Responses to Comments
on the
Draft Environmental Analysis

for the
**Low Carbon Fuel Standard and
Alternative Diesel Fuel
Regulations**

Released September 21, 2015
to be considered at the
September 24, 2015 Board Hearing

Figure 1a
Results of Sierra Analysis of Statewide NOx Increases
Due to Biodiesel Use under the Proposed ADF Regulation

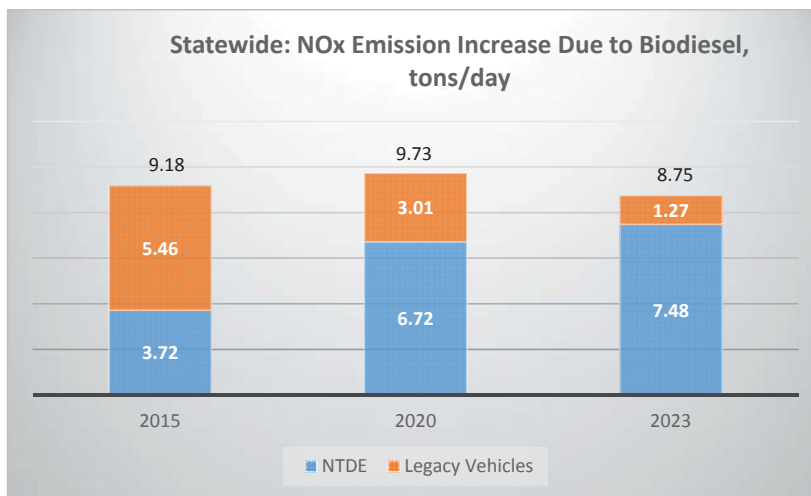
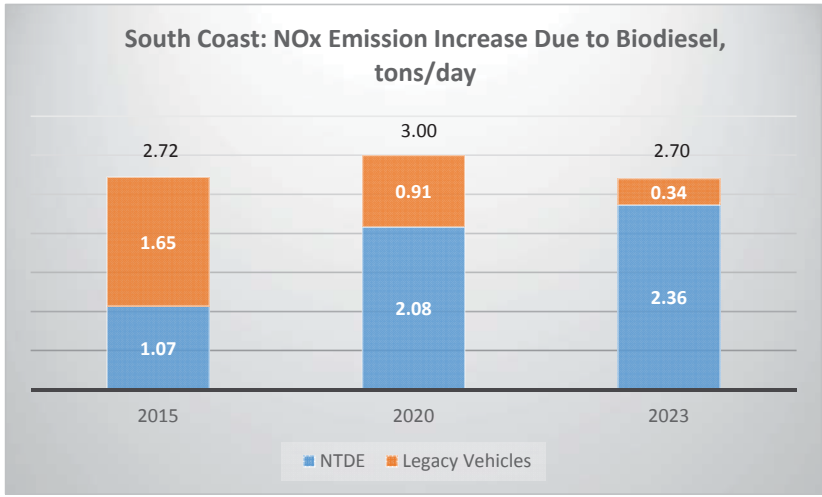
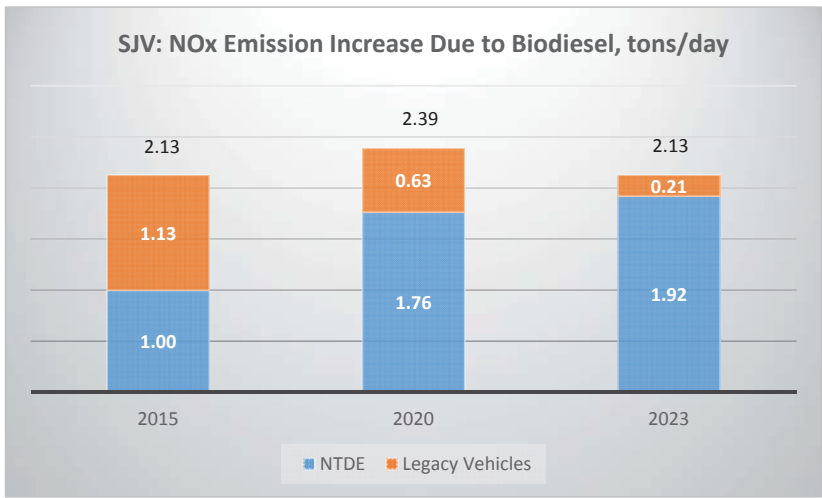
The results of the Sierra analysis are shown graphically in Figures 1a through c for the entire state as well as the South Coast and San Joaquin air basins, respectively. These figures also show the relative contributions of legacy vehicles and NTDEs to the total estimated for each area and year. As shown, the contributions of NTDEs to increased NOx emissions are substantial in 2015, and dominate the impacts in 2020 and 2023. Further data supporting these results are provided in Tables 6 through 8 at the end of this attachment.

Figure 2
The Impact of Biodiesel on NTDE NOx Emissions

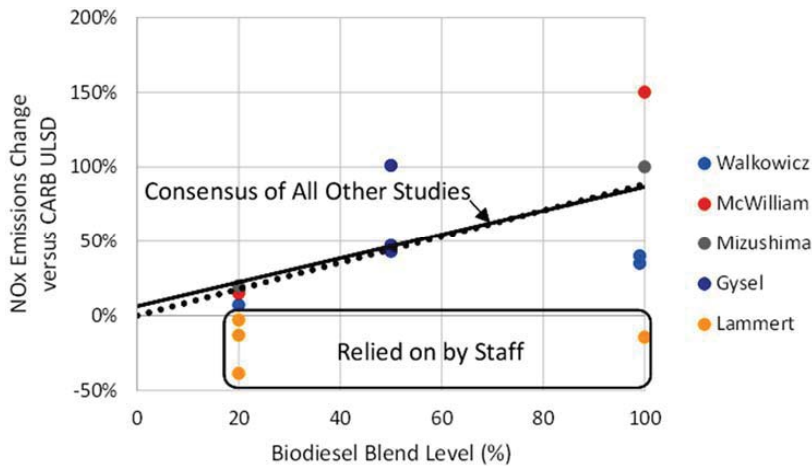
As indicated above, the Sierra analysis uses the results from an assessment of existing data regarding biodiesel impacts on NOx emissions from NTDEs performed by Rincon Ranch Consulting. The key findings of that analysis are shown in Figure 2 (reproduced with permission), which establishes that the available data for biodiesel impacts on NTDE NOx emissions follow a linear relationship just as they do for legacy vehicles.

Clearly, if CARB staff were truly taking a “precautionary approach” to the issue of biodiesel impacts on NTDE NOx emissions, they would also rely on the results of the analysis summarized in Figure 2.

Figure 3a
Results of Sierra Analysis of Statewide NOx Increases Due to Biodiesel Use in All NTDEs under the Proposed ADF Regulation

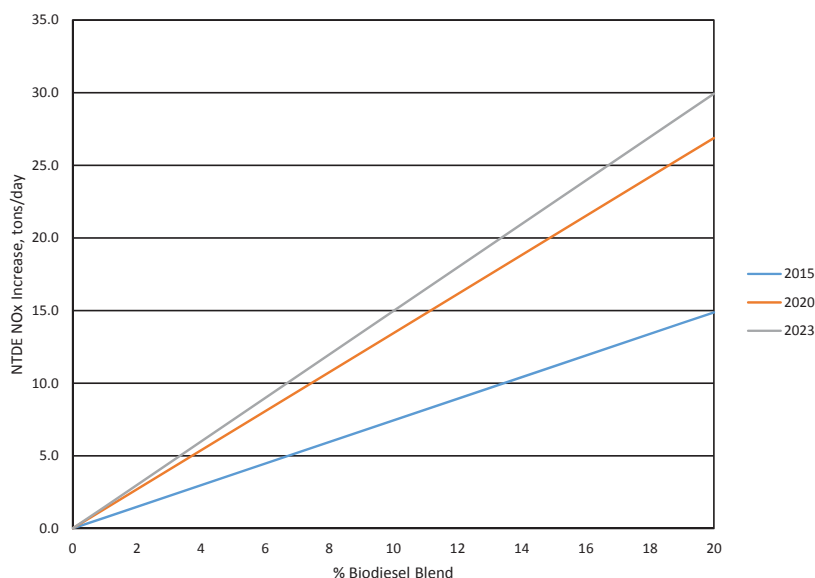
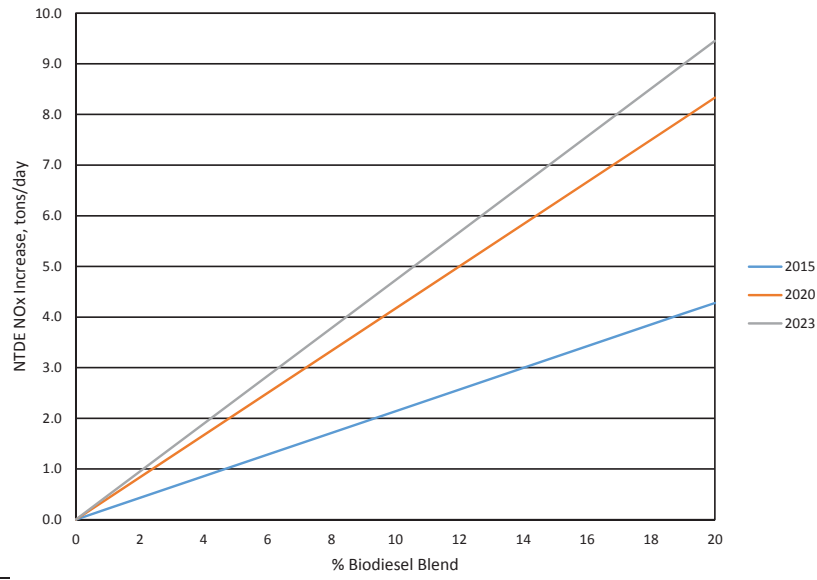
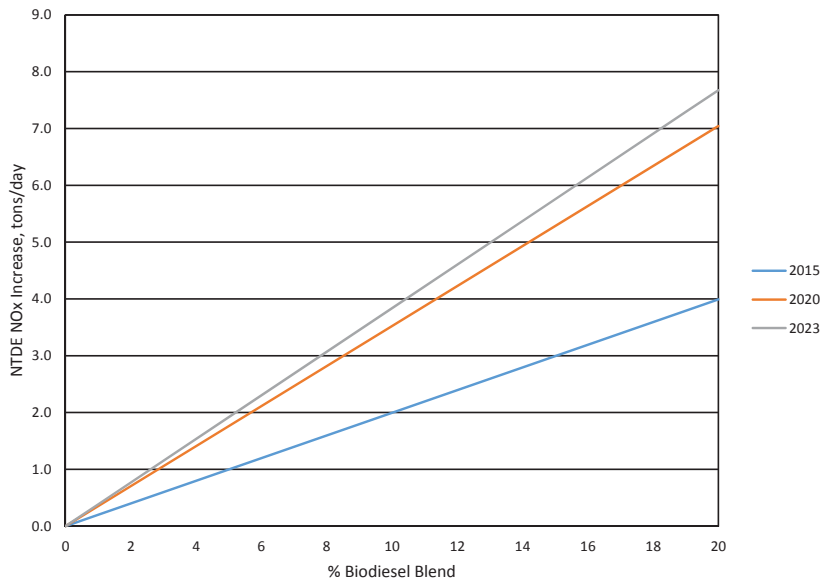
As shown, the potential NOx increases from extensive use of higher level biodiesel blends in NTDEs is quite large. Furthermore, although the results shown in Figures 3a through 3c are maximum potential impacts, they can again be simply scaled for other cases. For example, in order to estimate statewide NOx increases from B20 use in 50% rather than 100% of NTDEs, one would simply multiply the value of 30 tons per day by 0.5 (50/100) to arrive at a 15 ton per day increase. Finally, it should be noted that the values in Figures 3a through 3c reflect both on- and off-road NTDEs as described above for the Sierra analysis of B5 impacts.

Figure 1-1
Linear and Staff Threshold Models for Biodiesel NOx Impacts

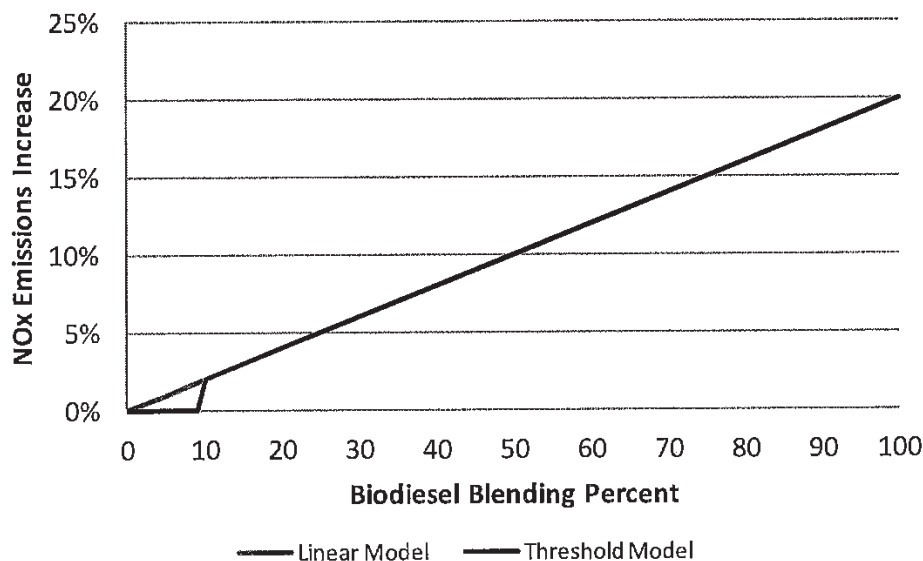
Existing research on the NOx emission effects of biodiesel has consistently been conducted under the hypothesis that the emission effect will be linearly proportional to the blending percent of neat biodiesel (B100) with the base diesel fuel. The Linear Model that has been accepted by researchers is shown as the blue line in Figure 1-1. The Staff position cited above is that biodiesel fuels do not increase NOx emissions until the fuel blend reaches 10% biodiesel. This so-called Staff Threshold Model departs from the Linear Model that underlies past and current biodiesel research by claiming that NOx emissions do not increase until the biodiesel content reaches 10 percent.

Figure 2-1
NOx Emission Increases Observed in Biodiesel Research Cited in Staff ISOR

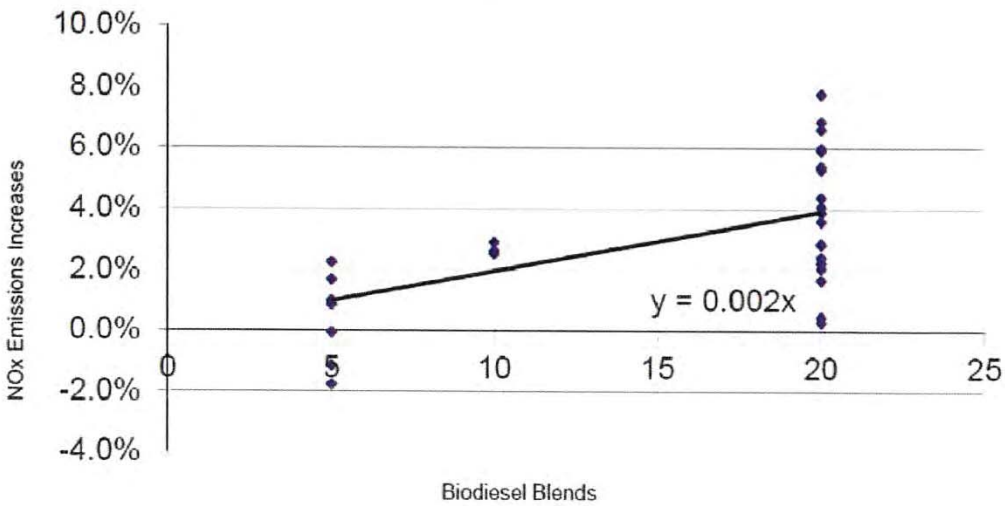
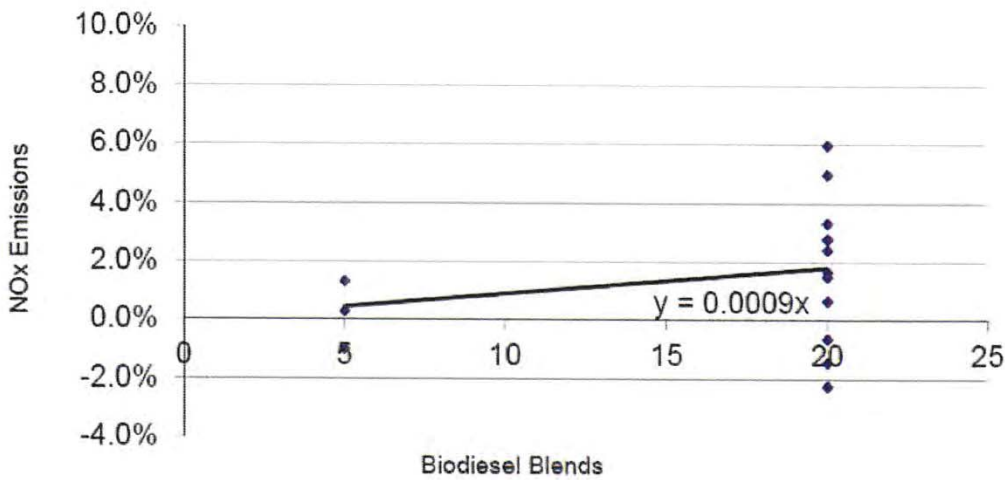
- The same result – reduced NOx emissions for some fuels and engines – has sometimes been observed in past research, as evidenced by the emissions data considered by CARB staff in ISOR Figure B.3 (reproduced in Figure 2.1 below). As shown, some animal-based B5 and B20 fuels reduced NOx emissions while others increased NOx emissions with the overall conclusion being that NOx emissions increase in direct proportion to biodiesel content of the blends and that there is no emissions threshold.
- Increasing cetane is known to generally reduce NOx emissions and has already been proposed by CARB as a mitigation strategy for increased NOx emissions from biodiesel¹⁴. The unusual cetane number response in the blending and the high cetane number of the B5-animal fuel may account for the results presented in the recently released study.

Figure 2-1 reproduces two exhibits from Appendix B that show increasing trends for NOx emissions with the biodiesel blending level. Based on the slopes of the trend lines,

Figure 2-2
Impact of Biodiesel Blends on Percent NOx Change for the 5.9L ISB Engine Operation Over the FTP Cycle

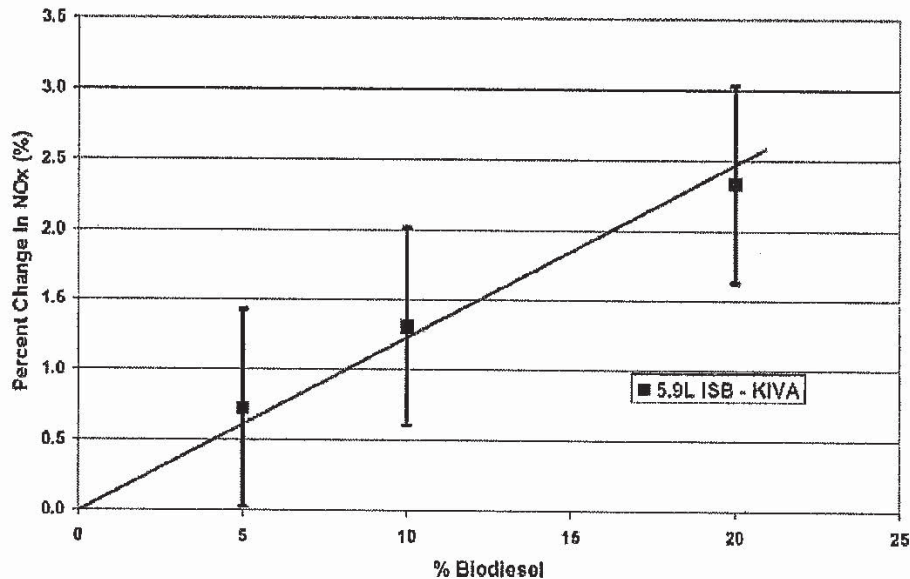
The study notes that two other studies “show that NOx emissions increase nearly linearly with the increase in the percentage of biodiesel added to diesel fuel.” Eckerle’s Figure 21 (reproduced below as Figure 2-2) indicates a NOx emissions increase at B5, which is the basis for the statement in the abstract that “Results also show that for biodiesel blends containing less than 20% biodiesel, the NOx impact over the FTP cycle is proportional to

the blend percentage of biodiesel.” The authors clearly believe that biodiesel fuels have NOx emission impacts proportional to the blending percent at all levels including B5.

Figure 3-1a
 Durbin 2011 Assessment: 40 mph Cruise Cycle NOx Emissions Increases
 for Soy-Biodiesel Blends (2006 Cummins Engine)

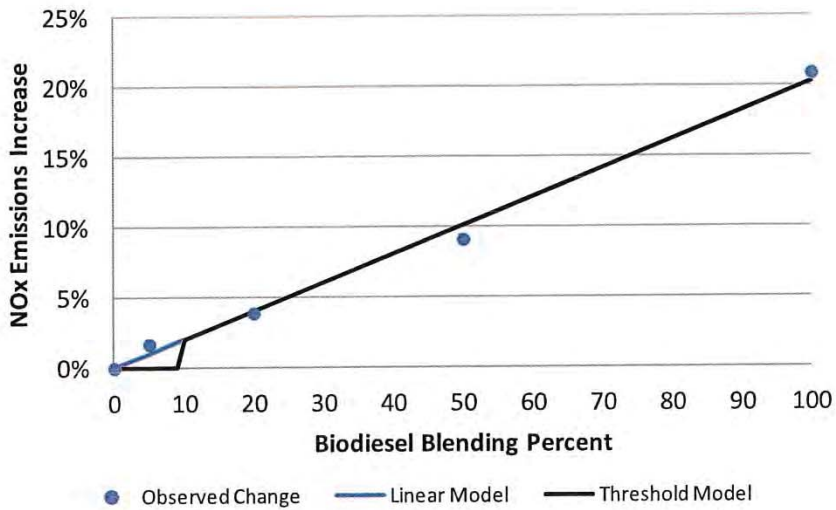
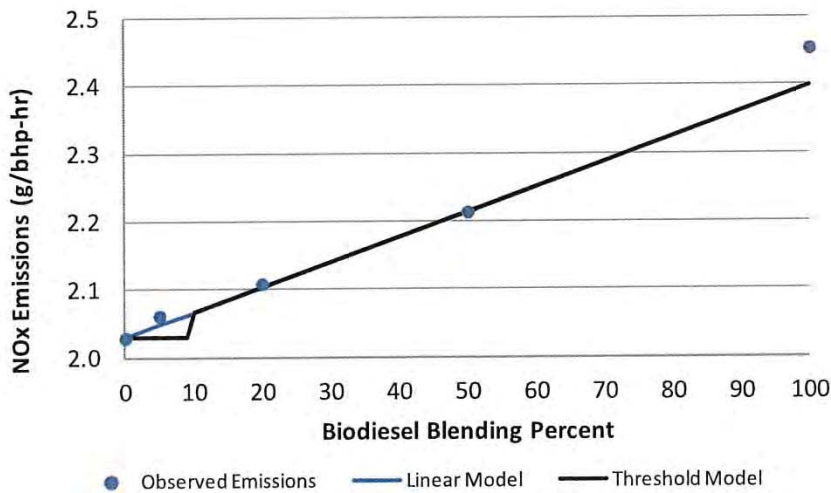
Figures 3-1a and 3-1b display the trend of NOx emissions with blending percent for the soy-based biodiesel on the 40 mph cruise cycle. Figure 3-1a plots the percentage increases as reported by Durbin 2011 in contrast to two different analytical models for the relationship:

In Figure 3-1a, the linear model is an Excel trendline for the computed percent changes. While the data violate a key assumption for the proper use of regression analysis, this approach is the only way to establish a trendline given the form in which Durbin 2011 tabulates the data and presents the results of its testing.

Figure 3-1b plots the actual measured emission values in g/bhp-hr terms in contrast to the same two analytical models. Here, the linear model line is determined through a proper use of regression analysis, in which each emission average in g/bhp-hr terms is weighted inversely by the square of its standard error, using the data for ULSD, B20, B50 and B100 (i.e., excluding the B5 data point). In the case of this engine and biodiesel fuel, both forms of assessment show generally the same trend for NOx emissions as a function of blending percent. Although the NOx emission increases for B5 may fail the t-test for significance, emissions are increased at B5 and the B5 data point is fully consistent with the Linear Model. The Threshold model is clearly a less-satisfactory representation of the test data.

Note that the slope of the trendline (Figure 3-1a) is greater than the slope of the regression line (Figure 3-1b). In the latter figure, the B100 data point stands above the regression line, which passes below it. The regression line (but not the trendline) is fit in

Figure 3-2a
 Durbin 2011 Assessment: FTP NOx Emissions Increases for Animal-based Biodiesel Blends (2006 Cummins Engine)

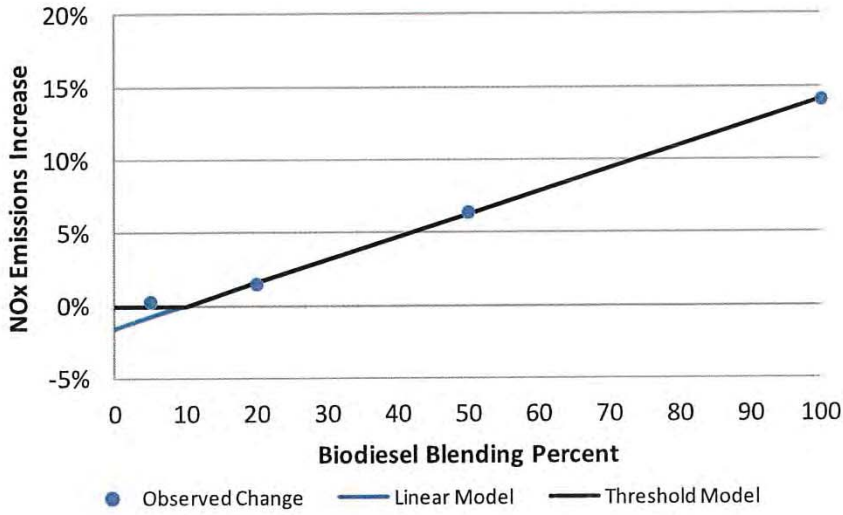
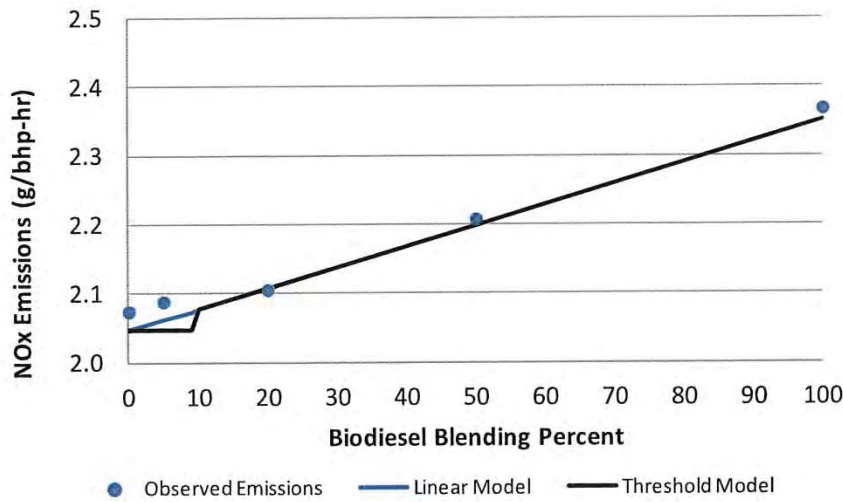
Figures 3-2a and 3-2b display the trend of NOx emissions with blending percent for the animal-based biodiesel on the FTP test cycle as reported by Durbin 2011 and as re-assessed in this report using regression analysis, respectively. As Figure 3-2a shows, the NOx percent change values reported by Durbin 2011 appear to follow the Staff Threshold model in that NOx emissions are not materially increased at B5, but are increased significantly at B20 and above. As a result, the blue trendline in the figure (fit from the B20, B50 and B100 data points) has a negative intercept.

Figure 3-2b paints a very different picture from the data. Here, the ULSD and B5 data points stand above the weighted regression line (blue) developed from the data for ULSD, B20, B50 and B100. In the data used to fit the regression line, the ULSD data point has the largest uncertainty (± 0.013 g/bhp-hr) while the other three data points (B20, B50, and B100) have uncertainties of ± 0.002 g/bhp-hr (one case) and ± 0.001 g/bhp-hr (two cases). Considering all of the data, the B5 data point has the second highest uncertainty (± 0.007 g/bhp-hr). The regression line closely follows a linear model with a high R^2 (0.981) considering the weighted errors, while the ULSD and B5 points lie above it.

Because the ULSD data point is subject to more uncertainty and appears to be biased high compared to the regression line, the NOx percent changes computed by Durbin 2011 are themselves biased. The trendline result in Figure 3-2a that appeared to be supportive of the Staff Threshold model now appears to be the result of biases in the ULSD and B5 emission averages.

Figure 1. CARB Biodiesel Forecasts

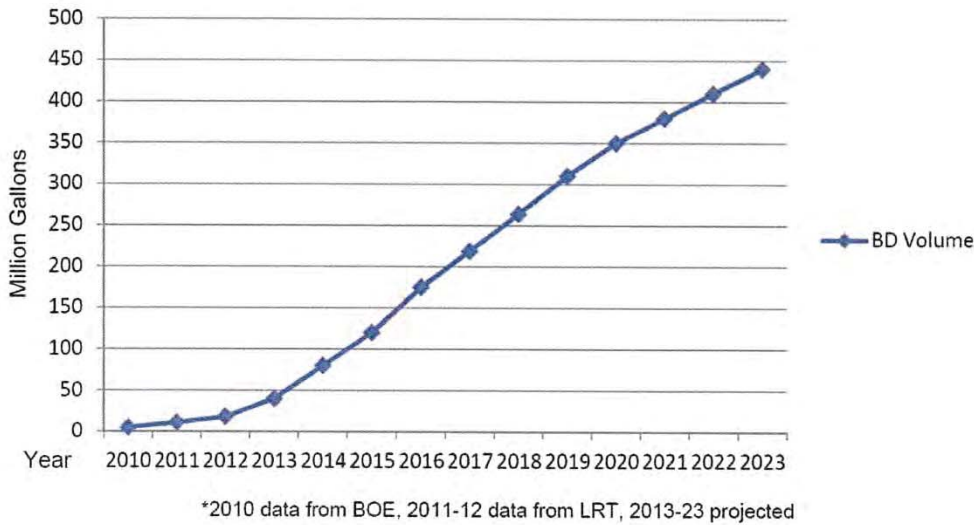
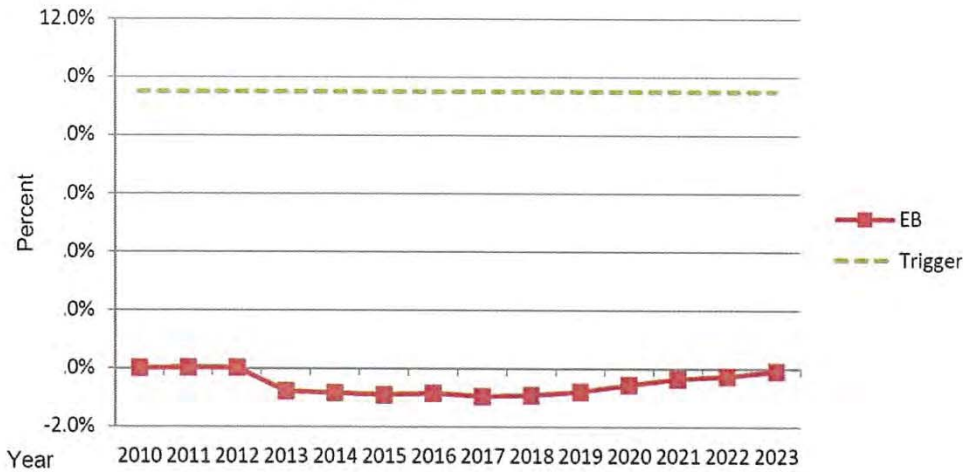
Source: CARB Initial Statement of Reasons. Note that Figure 6.5 is reproduced directly from the ISOR, which is missing some increments on the y-axis.
